R22 SERVICE BULLETIN SB-122

SUBJECT: Clutch Assembly Retainer Replacement

EFFECTIVITY: A018-1 & -2 clutch assemblies with early forward and/or aft retainer, described below.

FIGURE 2

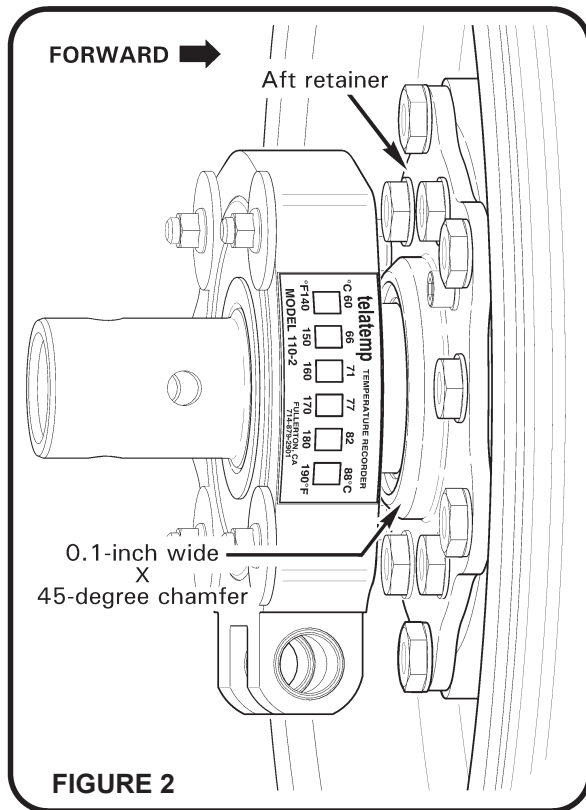
3. Refer to Figure 2. If aft retainer does not have pictured 0.1-inch wide X 45-degree chamfer, order:
 - 1ea A168-3 Rev L (or subsequent) retainer,
 - 1ea A215-035 o-ring, &
 - 1ea A966-1 seal
4. Per R22 Maintenance Manual (MM) § 7.213, remove & discard affected retainer(s).
5. Using MT642-3 pressing tool (or equivalent), press new, dry A966-1 seal flat-face first into counterbore of room-temperature replacement retainer(s), until seal contacts retention lip.
6. Using new o-ring, install replacement retainer(s) with seal per MM § 7.213.

FIGURE 1

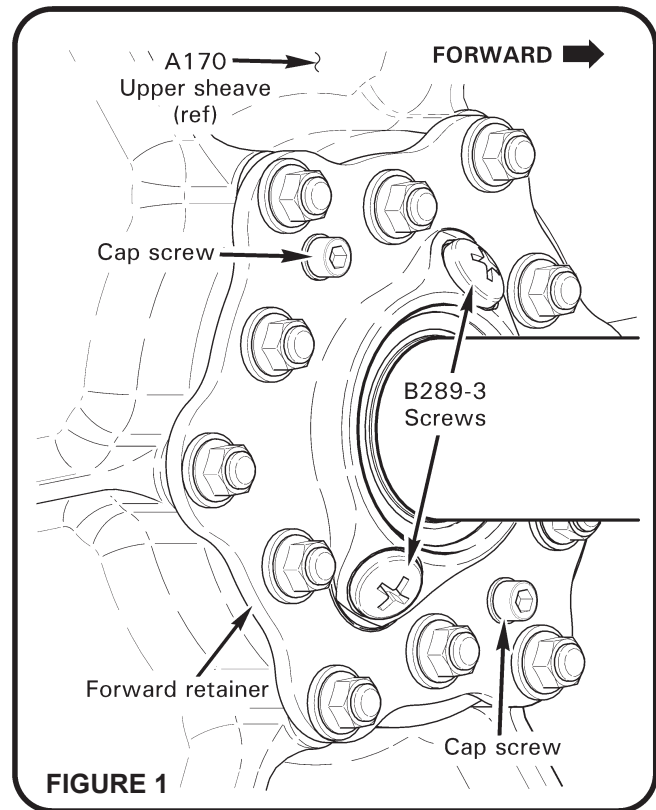
1. Refer to Figure 1. If cap screws are not present then submit clutch assembly for upgrade at an R22 Service Center authorized to perform Component Maintenance. Alternately, replace clutch assembly with compliant version.
2. If cap screws are present, but (2) B289-3 screws are not present, then order
 - 1ea A168-4 retainer,
 - 1ea A215-035 o-ring,
 - 1ea A966-1 seal, &
 - 2ea B289-3 screws

All A168-4 retainers have an integral seal-retention lip.
